SUBJECT: SALEM NUCLEAR GENERATING STATION, UNITS 1 AND 2 – STAFF
ASSESSMENT OF RESPONSE TO 10 CFR 50.54(f) INFORMATION
REQUEST – FLOOD-CAUSING MECHANISM REEVALUATION
(CAC NOS. MF3790 AND MF3791)

STAFF ASSESSMENT BY THE OFFICE OF NUCLEAR REACTOR REGULATION

RELATED TO FLOODING HAZARD REEVALUATION REPORT

SALEM GENERATING STATION, UNITS 1 AND 2

Figure 3.2-3. Precipitation Hyetograph Used in the Local Intense Precipitation Analysis (PSEG, 2014a, FHRR Figure 2.1-2)

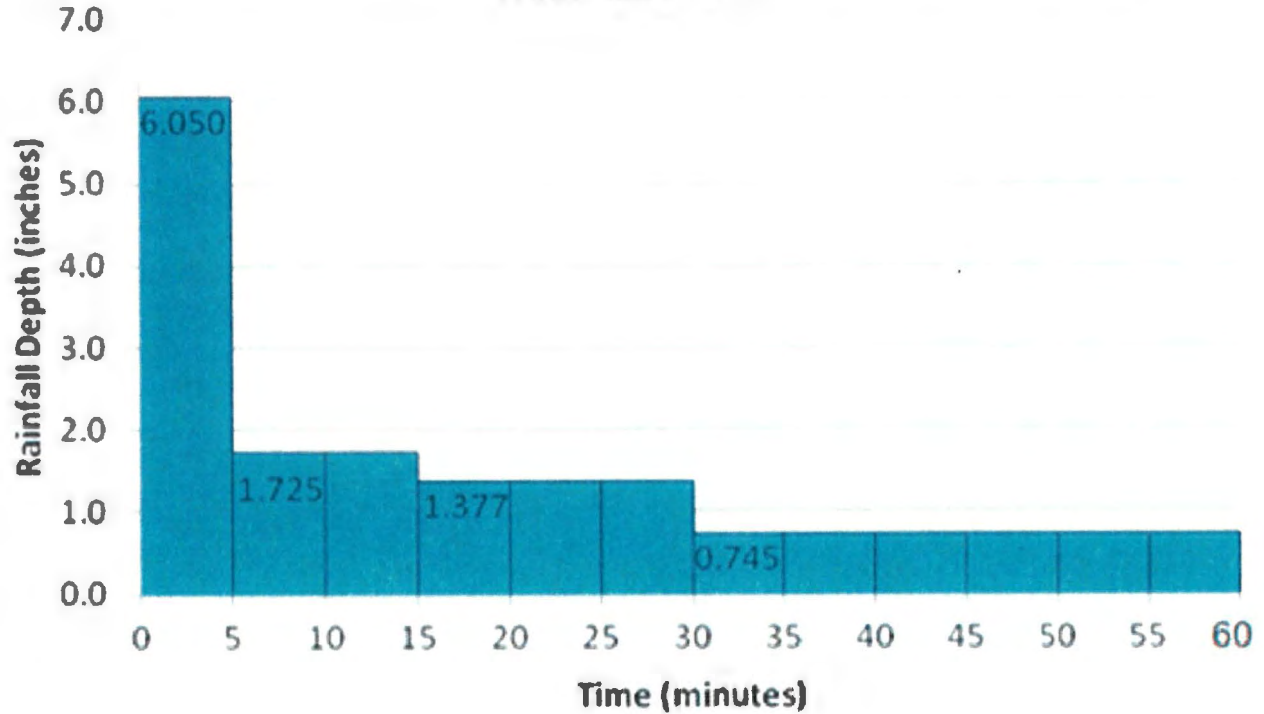
The licensee stated that the PMP precipitation hyetograph, shown in Figure 3.2-3 was developed using the methodology described in NUREG/CR-7046 (NRC 2011e).

The licensee used 5-min increments to construct the hyetograph, with the most intense precipitation flux applied during the initial 5-min increment with the precipitation rate decreasing during successive time increments (PSEG, 2014a). The NRC staff verified that the licensee followed the example described in Appendix B of NUREG/CR-7046.
